20 February 2026

Review Ashbourne Fast Track Development

Our clients own Lot 5 DP 365568, Record of Title 265791 (0 Odlum Drive, Matamata). The Applicant previously advised that "5 Odlum Drive is not included in the proposed Ashbourne Development," yet Table 2 of the Updated Stormwater Management Plan (30 January 2026) lists our client's property as part of the subdivision (Extract Attached marked 'A'). Across the new memoranda filed the Applicant has neither corrected this error nor explained the inclusion of our client's property. The Panel should direct the Applicant to remove Lot 5 DP 365568 from Table 2 and all related documentation.

Figure 23: Overall Pre & Post Development Flood Map RCP 8.50 - Sensitivity

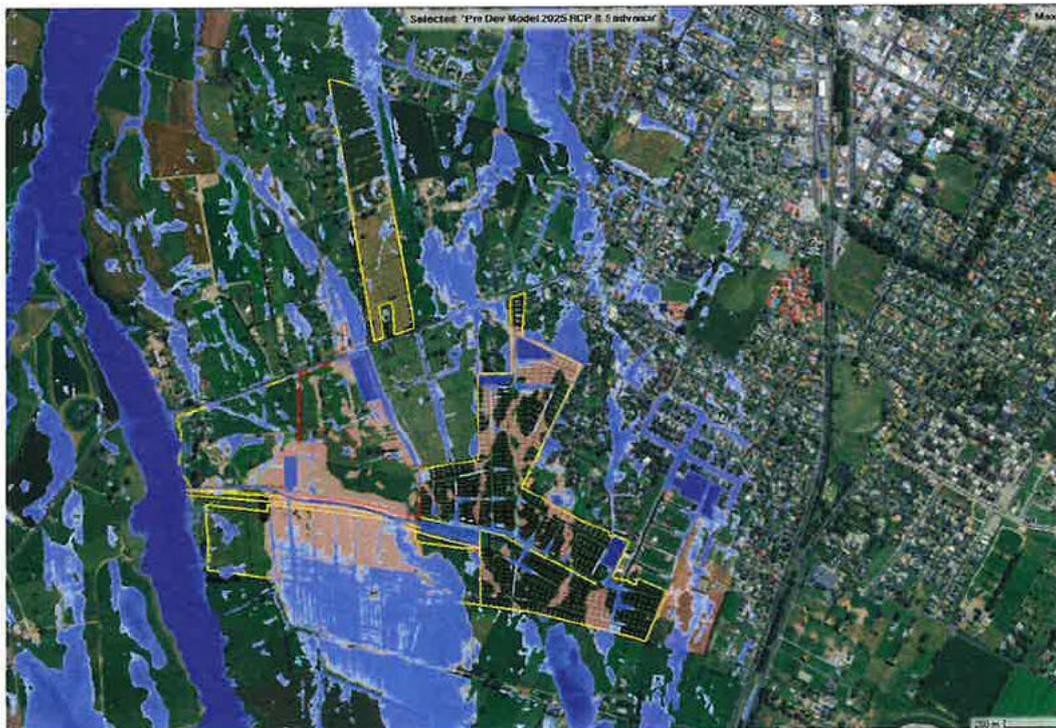
This is the fundamental concern of our client. Our clients' property sits adjacent to the northern boundary and appears on page 47-49 of updated Storm Water Management Plan to be in the path of potential overflow and flooding (Extract Attached marked 'B').

- Excess stormwater may flow onto their property during major storms.
- Their property appears to be incorporated into the stormwater strategy without their consent.
- The property's future use and value could be severely compromised.
- Effects on their land have not been properly assessed.

- Require the Applicant to clarify whether Lot 5 DP 365568 (0 Odium Drive, not "5 Odium Drive") is included in any aspect of the development, including stormwater, drainage, access, or infrastructure.
- Direct the Applicant to correct Table 2 page 5-6 of the Updated Storm Water Management plan that includes our client's property and all ancillary documentation accordingly or properly disclose if our clients property is intended to be affected.
